AEROSOL NEUTRALIZATION ISSUE MODEL 3077(A)

APPLICATION NOTE 3007-001 (A4)

Figure 3: 3077(A) insert part number 3007022

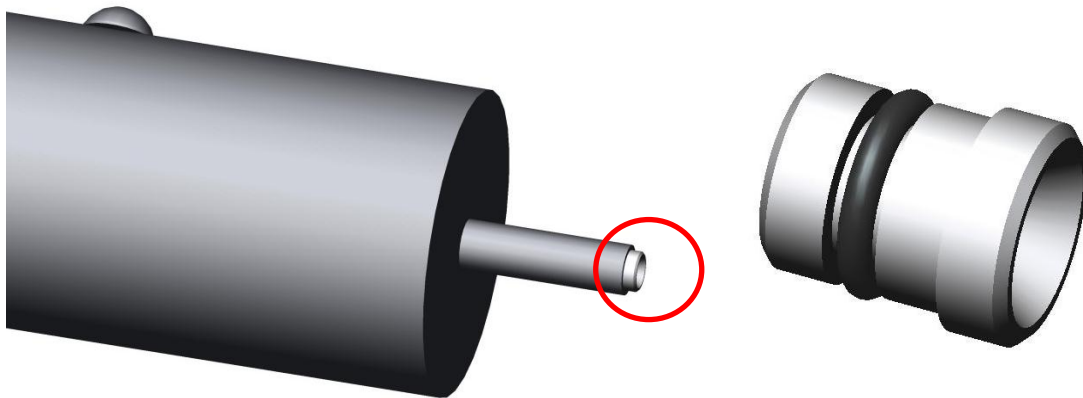
- The first solution is an updated inlet block for the 3082 classifier. It includes a flow mixing element upstream of the neutralizer. The flow mixing element sufficiently alters flow patterns inside the neutralizer such that flow recirculation is avoided. It is present in all 3082 classifiers with date code June 2014 or later and will be installed in any 3082 classifier that is returned to TSI for service.
- The second solution is an insert for the 3077(A) neutralizer (part number 3007022) shown in Figure 3 which can be installed in the inlet of the neutralizer. This insert sufficiently alters flow patterns inside the neutralizer such that flow recirculation is avoided. Current 3077(A) owners who wish to use the insert can obtain a free insert by registering with TSI at www.tsi.com/3077kit with the serial number of the neutralizer.

Yes. Press the insert into the inlet of the neutralizer. The insert is held in with a radial-seal O-ring. The insert is removable for cleaning if necessary.

Figure 5: Flow mixing insert diffusion loss contribution at 1.5 L/min aerosol flow with pre-neutralized aerosol

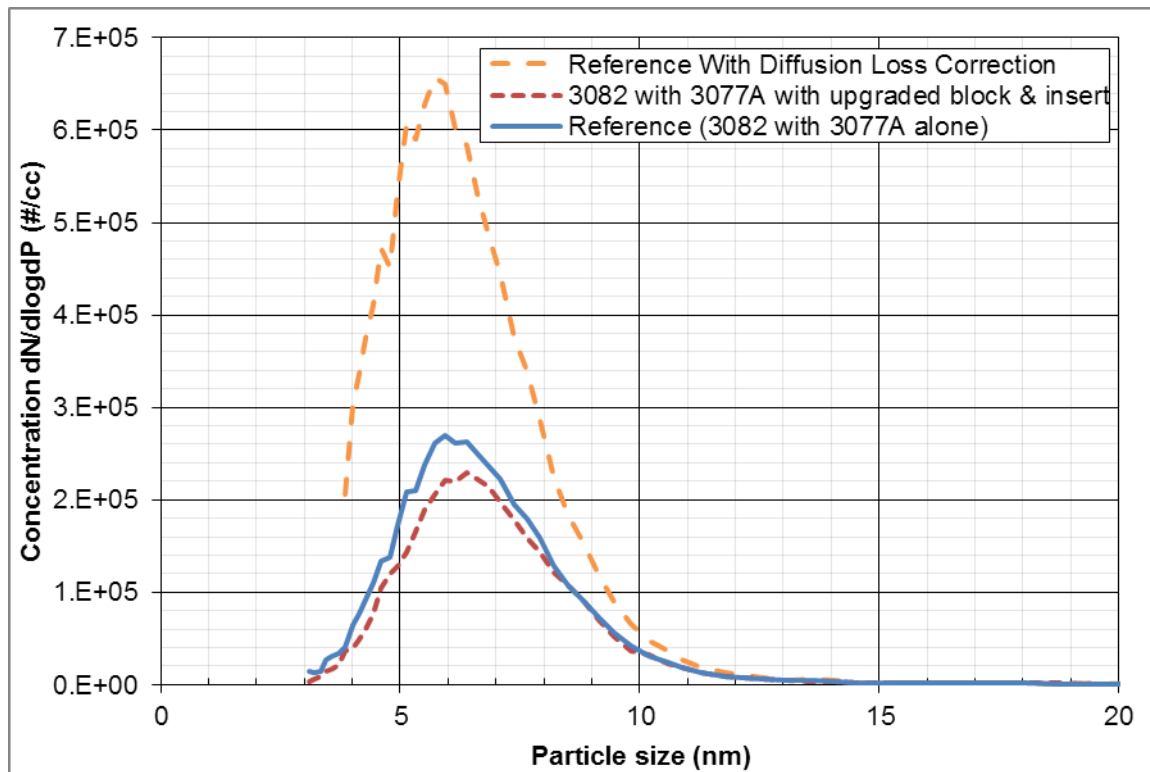
See Figure 5. The total aerosol concentration for the 3077(A) neutralizer with neutralizer insert was measured to be within $\pm 10\%$ of the reference total concentration down to 8 nm. At the smallest sizes (< 8 nm), where diffusion losses are highest, diffusion losses due to the neutralizer insert are measurable but are an order of magnitude less than the overall diffusion losses of the SMPS system flow path. Losses due to the new inlet block (not shown) were also measured between 2 and 200 nm and are negligible ($< 2\%$).
